Cabinet Member for City Services

30th July 2018

Objections to Proposed Waiting Restrictions (Variation 6)

Appendix A – Summary of proposed restrictions, objections, letters of support and responses

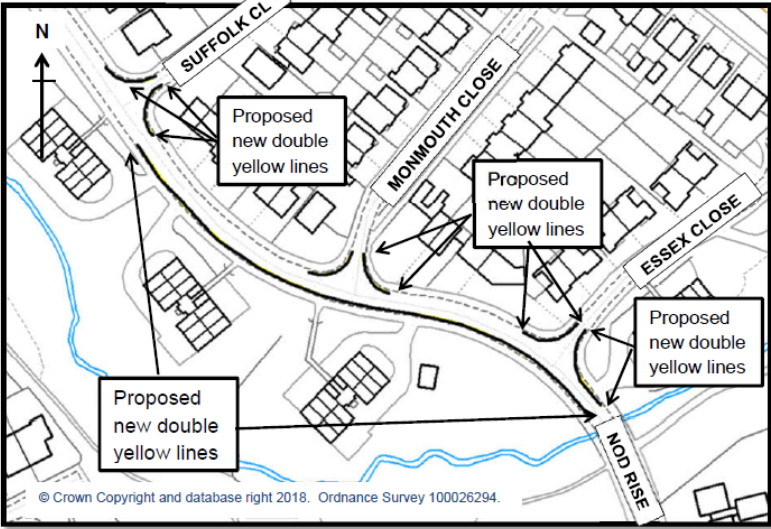
Location (Ward)	Craven St/Lord St (Whoberley)
Original Request	Chapelfields Area Traders and Residents Association (CARTA) requested the installation of double yellow lines at the junctions of Craven Street with Duke Street, Lord Street, Mount Street and Sir Thomas White's Road (both sides). There are existing double yellow lines at the Sir Thomas White junction. Request supported by Cllr Innes & Cllr Bally Singh
Proposal	<p>Double yellow lines for junction protection</p>
Objection 3	<p>There are double yellow lines at the other end of Lord Street at the junction with Allesley Old Rd. These are casually ignored causing a "blind" junction that is particularly dangerous at peak times. I log my objection on the basis that if the Council cannot enforce current, more pressing, traffic concerns then why waste money implementing further measures they will fail to enforce? I fear this maybe a waste of public money, at a time of unprecedented funding cuts, to satisfy the traders and residents association.</p> <p>Additional comment received referring to rule 243 in the highway code (relates to not parking at a junction) and if this was enforced there would be no need for double yellow lines.</p>

Objection 4	<p>Objecting the grounds of road safety. The proposed waiting restrictions, especially on the acute junction at 56 Craven Street appear to mainly be for reasons of convenience with no obvious benefit for road safety at the junction. The proposed waiting restrictions will, however, place greater demand on other on-street parking in the area which is likely to increase the risk to pedestrians and other vulnerable road users</p>
Objection 5	<p>This is a Conservation Area and double yellow lines are always inappropriate in such a place. The negative visual impact will be considerable.</p> <p>The area is by a great margin the best entertainment area in Coventry. People come here because of its relaxing and peaceful character. There are much worse problems than difficult corners and the worst one is lack of parking. The second worse is speeding. There are a few idiots who treat Craven Street as a high speed Rat Run. It can be very dangerous.</p> <p>I am proposing therefore that instead of aggravating the parking problem by removing potential parking places we should solve the problem of the junctions by tackling several matters. Refers to use of road humps at specific locations, reduction to 20mph.</p> <p>Advises of history living in local area, and that proposals will not be favourable to me but I believe they are a good solution to a difficult problem. Making Mount Street and Lord Street one-way might provide a solution to the difficulty of negotiating the junctions with Craven street.</p>

Objection	Objection on behalf of CARTA, request that the double yellow lines that are due to be painted

6	be of the minimum length legally permitted. Suggests 2.5m
Response to objection	<p>The double yellow lines at the junctions are proposed in accordance with the advice from the Highway Code in regard to parking at a junction. The Highway Code (243) states 'Do not stop or park opposite or within 10 metres (32 feet) of a junction, except in an authorised parking space'. This is to provide visibility at a junction.</p> <p>Conservation does not mean double yellow lines cannot be installed, they are being installed to address issues relating to problems at the junctions, and as referred to, there are already double yellow lines in the area.</p> <p>It should be noted that whilst parking guidance is provided in the Highway Code, Parking Services cannot assist to enforce parking at a junction without the necessary traffic regulation order, if there are no restrictions present only the Police can enforce.</p> <p>Recommendation – Install restrictions as advertised</p>

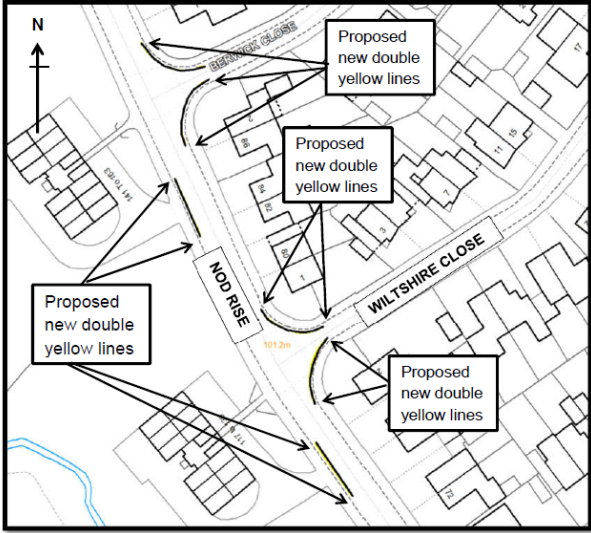
Location (Ward)	Dewsbury Ave /Barnack Ave (Wainbody)
Original Request	The double yellow lines were requested in a 203 signature petition. The additional restrictions were proposed following a meeting with Officers and the school.
Proposal	<p>Double yellow lines on northern side of road at mini roundabout and for junction protection at Barnack Avenue. In addition, a section of school time no waiting restriction is proposed to assist to improve safety around school by pedestrian exits</p> 
Objection 7	Whilst we welcome anything that will make the area safer for children and adults alike, we feel the result could be to move the parking further up Hexworthy Avenue, to another dangerous junction, on a bend, at the Hexworthy Avenue shops. To a certain extent this is already happening

Response to objection	<p>There is the potential with the introduction of any waiting restriction that parking will transfer to other areas. If approved, once the waiting restrictions are installed, site visits can be undertaken to determine whether any additional restrictions are considered necessary and these could be added to a future waiting restriction review</p> <p>Recommendation – Install restrictions as advertised and monitor.</p>

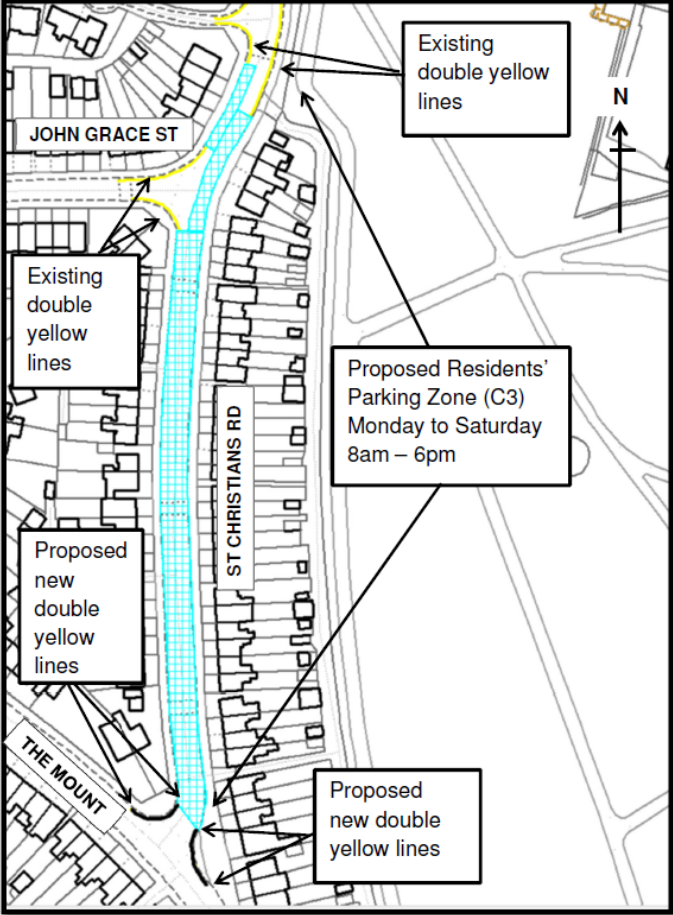
Location (Ward)	Nod Rise (Woodlands)
Original Request	Double yellow lines. Complaints received relating to visibility, concerns about parking on the bend and access issues at the flats. Requested by residents and supported by Ward Councillor
Proposal	<p>Double yellow lines on Nod Rise on the bend, at accesses to the flats and at junctions for junction protection</p> 
	Due to the number of objections that have been received (3) with similar reasons, the objections have been grouped together highlighting the main reasons for objecting to the proposal
Objections 12-14	<p>Nod Rise has for many years suffered from increased traffic but more importantly increased speeding. This has been raised many times over the years at the Mount Nod Residents Association meetings to no avail!</p> <p>If the reason is for traffic calming, then this will have no effect (cars, buses, white vans. large delivery vehicles delivering to the local retail outlets regularly flout the speed limits. Indeed some cars and motor bikes often reach speeds of 60+ mpg). By double yellow lining only the one side of the road by the flats, once the speedsters realise that there is nothing to come into contact with as they travel round the bend they will use this section of the road as a new F1 Race track !!</p> <p>By only yellow lining the road outside the 'flats side', you will then encourage people to park on the 'houses side' where it is often already difficult to get off our drives. It will also create blind spots for the residents occupying the houses along this stretch of Nod Rise.</p> <p>These are genuine concerns for myself and my neighbours and hope that you will consider taking them on board - indeed it would make better sense if both sides of the road were to be "yellow lined" if waiting restrictions are the problem.</p> <p>When I reverse off my drive traffic is on top of me instantly as they fly round the bend by the bridge and look as me as if to say what are you doing as they slam their brakes on!</p> <p>Putting double yellow lines on the edge of the closes we agree with but we object to the long stretch along Nod Rise. The parked cars that side slow the traffic down putting yellow lines will just increase there speed! The cars that do park that side</p>

<p>will move to our side of the road which is the blind side no one parks this side for that reason! A bus hit a lady's car parked this side just recently that's why no one parks this side it's too dangerous!</p> <p>The problem would be better sorted coming down Nod Rise from Broad Lane where the cars are double parked all the time and even park in the bus stop!!</p> <p>Believe that the double yellow lines outside of the flats will be a waste of tax payers money as they will not solve any problem. The parked cars will just be shifted to the opposite side of the road, and instead other problems will be created such as a potential increase in the speed of cars using the road (highly likely from what we have witnessed in [] years living here) and more danger will be created for residents pulling off their driveways.</p>
<p>Response to objection</p>	<p>The proposals were based on complaints received relating to visibility, concerns about parking on the bend and access issues at the Flats. As the request related to the majority of the road, the whole road was considered and in case of the possibility of displacement of parking to other junctions, the proposal was extended to include double yellow lines for junction protection at the remaining junctions, the extent of the double yellow lines is in accordance with the guidance in the Highway Code.</p> <p>The proposals are not a response to speed concerns, but to issues relating to visibility.</p> <p>If approved, once the waiting restrictions are installed, site visits can be undertaken and together with any issues highlighted by local residents, used to determine whether any additional restrictions are considered necessary. Any new or extensions to existing waiting restrictions could be added to a future waiting restriction review.</p> <p>Recommendation – Install restrictions as advertised and continue to monitor.</p>

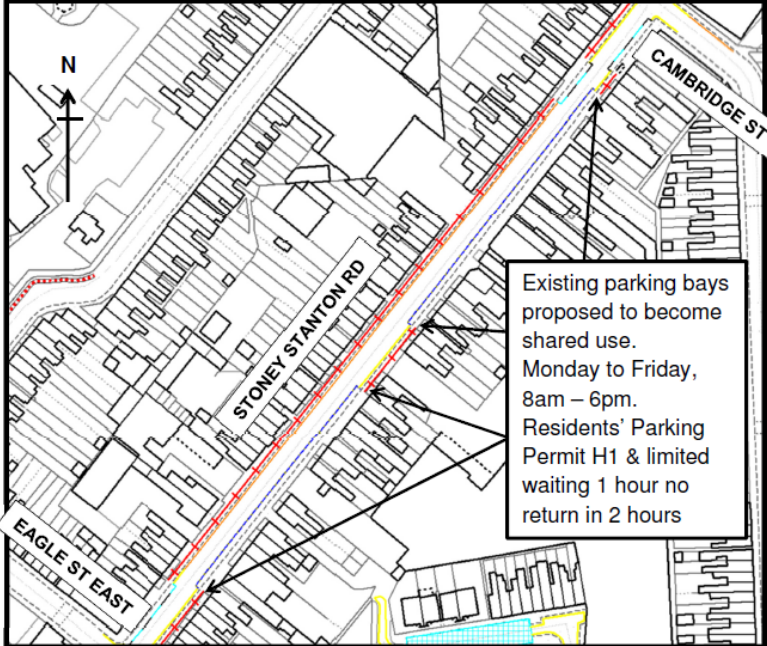
Location (Ward)	Nod Rise (by Wiltshire Court) (Woodlands)
Original Request	Double yellow lines. Complaints received relating to visibility, concerns about parking on the bend and access issues at the flats. Requested by residents and supported by Ward Councillor
Proposal	<p>Double yellow lines on Nod Rise on the bend, at accesses to the flats and at junctions for junction protection.</p>  <p>© Crown Copyright and database right 2018. Ordnance Survey 100026294.</p>
Objection 15	<p>I am writing on behalf of the Directors and the residents of the block [Wiltshire Court]</p> <p>The help of the City Council in addressing the safety concerns when we exit from our premises at Wiltshire Court onto Nod Rise is very much appreciated.</p> <p>However, we wish to register an objection to the current proposal, although we very much support the principle of restricting parking around the hazardous areas. When we view the proposed double yellow line layout shown in the plan contained in your letter, several of us who live at Wiltshire court, who are drivers, think that the placing of the waiting restrictions do not extend far enough to create the safe exit we were hoping to achieve. We would, therefore, ask you to reconsider and increase the extent of the double yellow lines.</p> <p>We attach the accompanying two photographs and video which were previously shown to our local Councillor, and which show the potential hazards when vehicles are parked on the road.</p>

Response to objections	<p>If approved, once the waiting restrictions are installed, site visits can be undertaken and together with any issues highlighted by local residents, used to determine whether any additional restrictions are considered necessary. Any extensions to existing waiting restrictions could be added to a future waiting restriction review.</p> <p>Recommendation – Install restrictions as advertised and continue to monitor.</p>

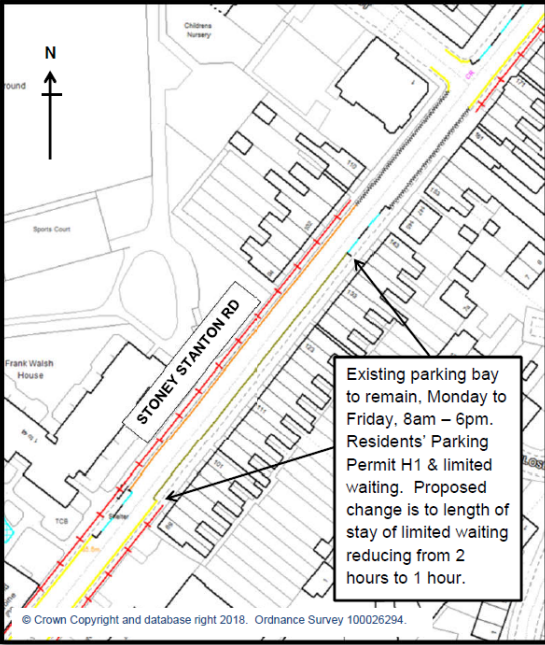
Location (Ward)	Oldham Avenue (Wyken)
Original Request	The residents' parking scheme was requested in a 46 signature petition, advising of issues relating to commuter parking associated with the hospital. Petition supported by Councillor Abbott.
Proposal	<p>Residents' Parking Scheme, times of operation 24 hours, 7 days a week.</p>  <p>© Crown Copyright and database right 2018. Ordnance Survey 100026294.</p>
Objection 16	<p>As a bit of background, the HQ was given to Scouts by the builder of the surrounding houses when that work had finished in the 1950s. Because of the layout of our buildings, we have always used the gap between the houses in Oldham Avenue as our entrance both for people and the occasional loading of trailers and cars with camping equipment. Apart from the buildings the area is mostly covered by grass and cannot be used as a permanent carpark.</p> <p>In recent years, we have rented out our HQ during the day to playgroups which have served the local area. The current one has been with us for several years.</p> <p>Because of these activities, we have a need for parking on Oldham Avenue and are concerned that the parking is being restricted to residents as suggested by the scheme and therefore object to it being introduced.</p> <p>The current playgroup operates 5 days a week during school term. They have 5 leaders with cars, working at various times from 7:30am till 4:00pm Monday to Friday. When they are open, they have about 24 children dropped off and picked up during the day at the start and end of their sessions, some of who will travel by car.</p> <p>On the Scouting side, we have up to 3 leaders who come by car for meetings between 5:30pm and 9:00pm Tuesday to Friday. The Rainbows, Beavers, Cubs and Scouts have between 15 and 20 in each section and meet on different evenings. Many are dropped off and picked up by car. We also go to the HQ outside these times, e.g. at weekends, for maintenance work, grass cutting, etc.</p>

Response to objections	<p>Recommendation – Install restrictions as advertised, but with eligibility for the issue of permits to the Scout HQ, in accordance with policy, namely 3 residents' permits and 3 visitor permits, for users of the building during the day and for users in the evening. In addition, in accordance with similar situations in existing schemes, allow the provision of some short stay (20 minute) permits for drivers dropping off children at this location.</p>

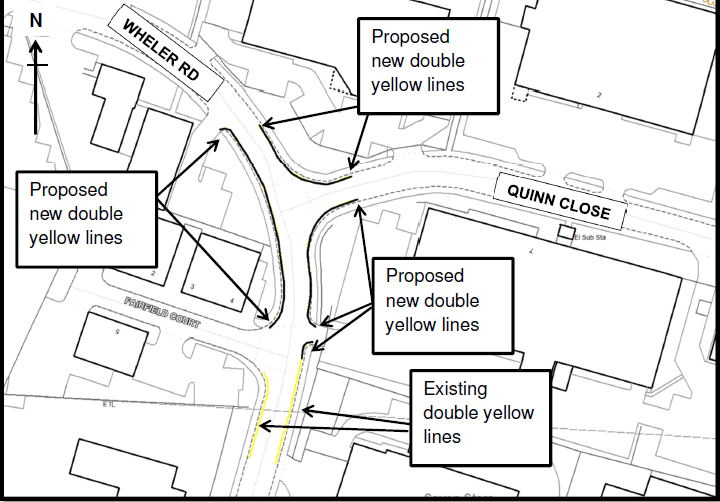
Location (Ward)	Stoney Stanton Road - limited waiting restriction (St Michaels)
Original Request	Change to limited waiting restriction proposed for consistency
Proposal	<p>Existing shared use parking bay (limited waiting & residents' parking) to remain in operation, but for consistency proposing to amend the limited waiting period from 2 hours to 1 hour so that all the shared use parking bays on Stoney Stanton Road have the same restriction.</p> 
Objection 22	<p>I object to the waiting time reduced from 2 hours to 1 hour. People come to visit us, do work in the house, etc. 2 hours is OK, but less than this is not OK. Why should my guests get a parking ticket? Have I been here for an hour? What unnecessary pressure. This is not fair and I object strongly.</p>

Response to objection	<p>The amendment to the limited waiting restriction is proposed for consistency. These shared use bays are existing, but new shared use bays are being proposed nearby (south of Cambridge Street). Where the new bays are proposed, there is already limited waiting, with a stay limited to 1 hour, to provide a turnover of parking spaces. Due to changing demands it is proposed that these parking bays become shared use, enabling residents to park on street without restriction if they have a permit.</p> <p>As this will result in a very similar restriction nearby, whilst a driver should always check the times a restriction applies, to avoid confusion it has been proposed to amend the limited waiting time so that all the shared use bays on this section of road have the same restriction.</p> <p>Residents can obtain visitor permits to enable their visitors to stay longer than the limited waiting restriction permits.</p> <p>Recommendation – Install restrictions as advertised</p>
